PITT-04-19-008

Re: NPDES Permit No.: ESG0500015001-1 Incompleteness Review Responses Pennsylvania Pipeline Project – Mariner East 2 Goldfinch Line HDD Reroute Jackson Township, Cambria County

Comments and Responses to March 20, 2019 Incompleteness Review Letter

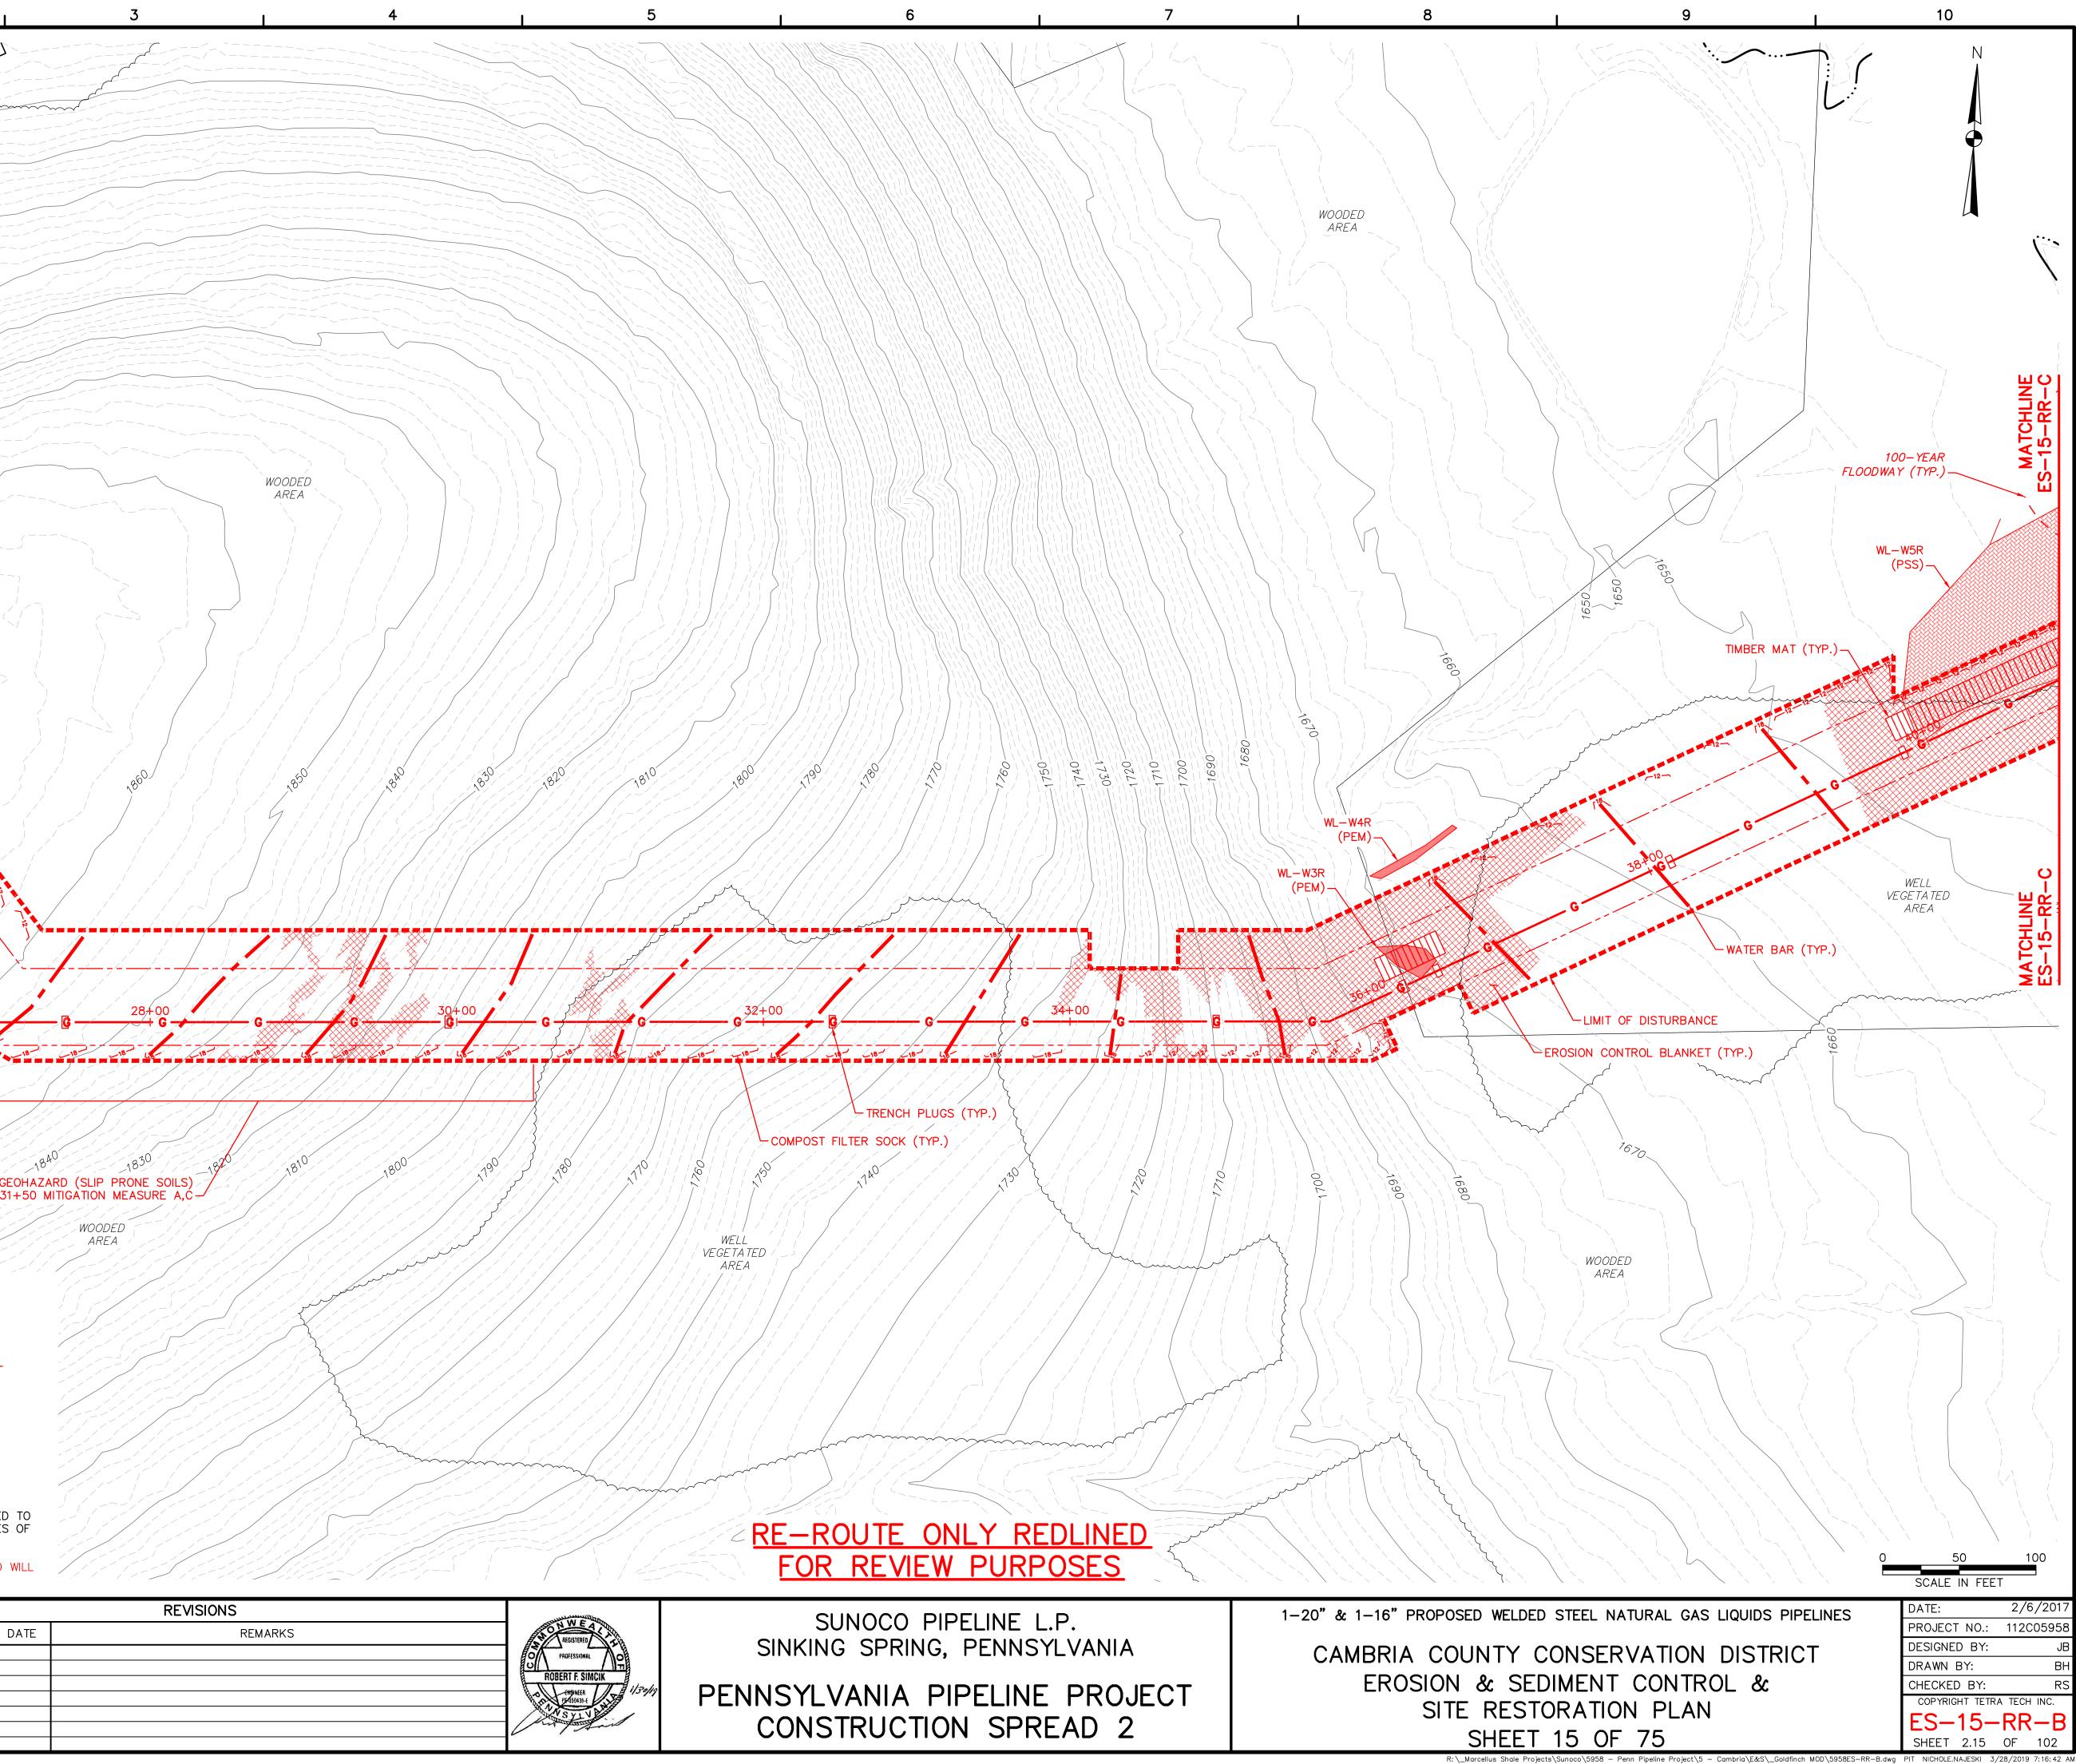
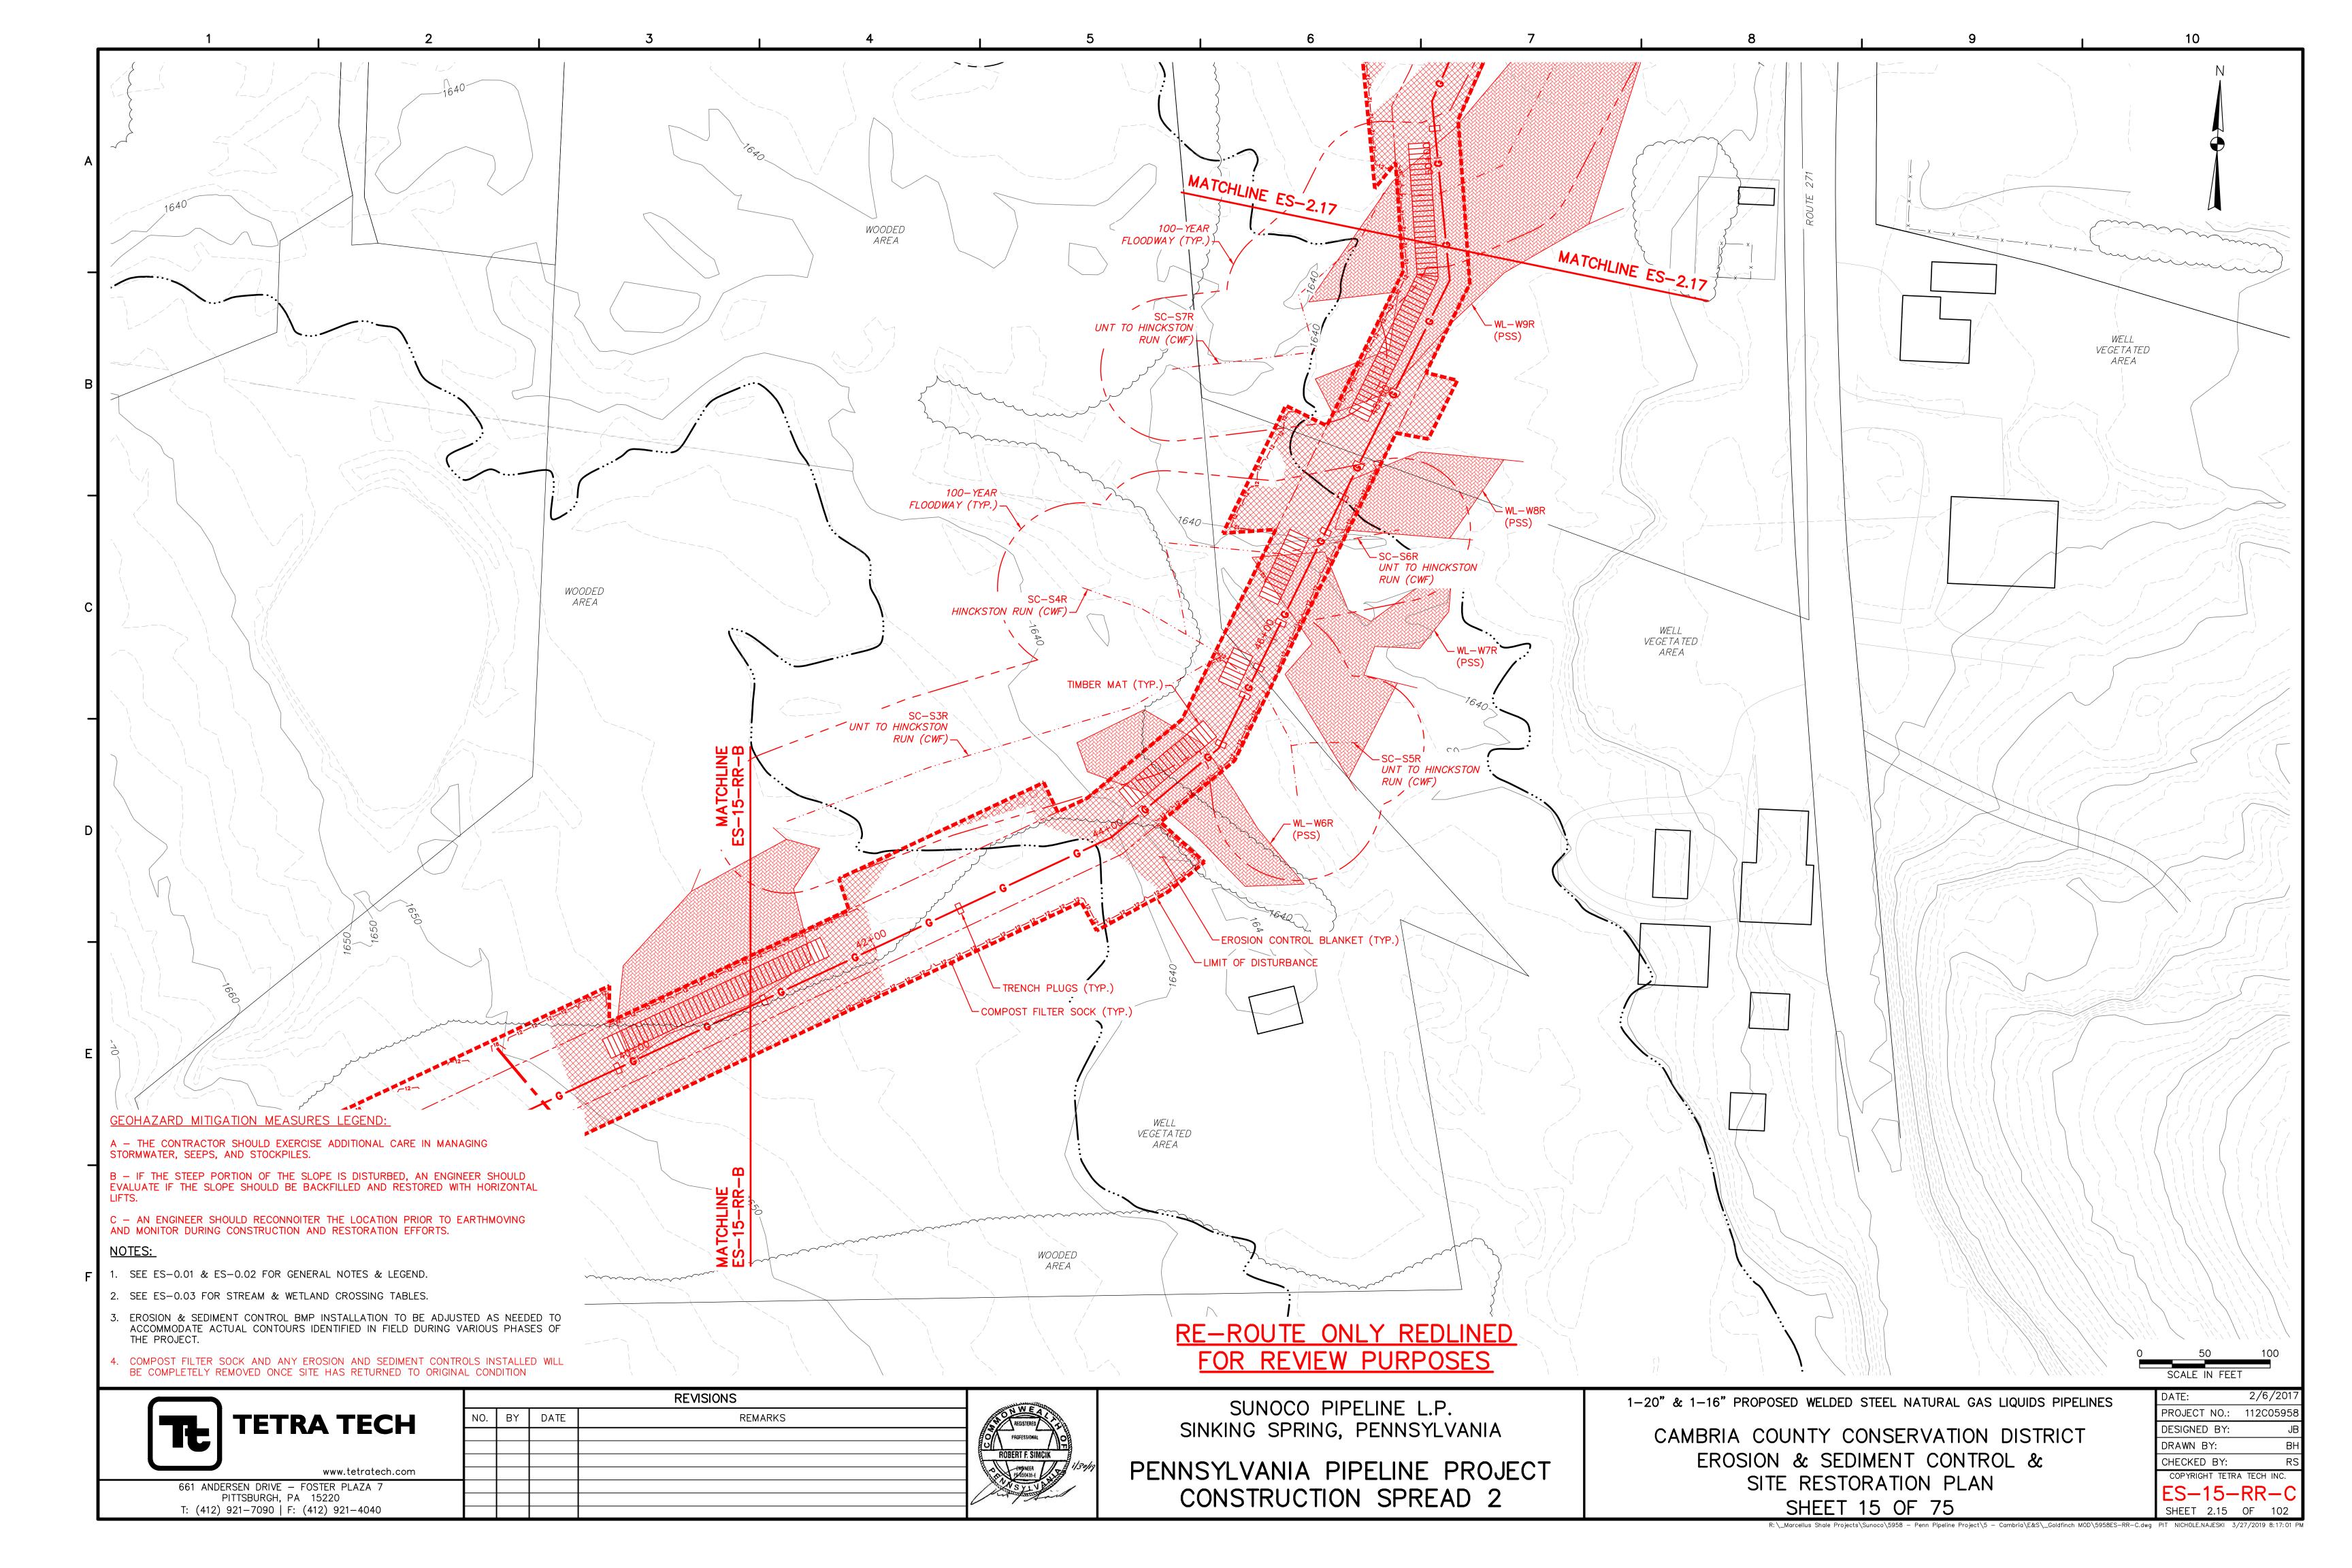
1.	102.4(b)(5)(vii): The Erosion and Sediment Plans do not discuss how and when the E&S BMPs will be removed from the wetlands. Include a note in	Attachment A of this response provides the updated plan sheets for ES-2.14, ES-15-RR-A, ES-15-RR-B, ES-15-RR-C, and ES-2.17.
ра ст е 1 Че	the E&S plans that the Compost Filter Socks will be removed once the site has been restored back to original conditions.	The figures were updated to include a note and show the proposed Compost Filter Sock within the wetlands and appropriate Erosion and Sediment control devises. Calculations to support the controls also provided.
		Maintenance and removal of erosion control devices is presented in the Narrative under Construction Sequence number 18 (pg 3-3) and applies to the wetland areas that are now included on the E&S plan sheets.

After construction and once the disturbed area tributary to the compost filter sock in the vicinity is permanently stabilized with vegetation, the diversions and level spreaders will be removed along with other erosion and sedimentation control BMPs.
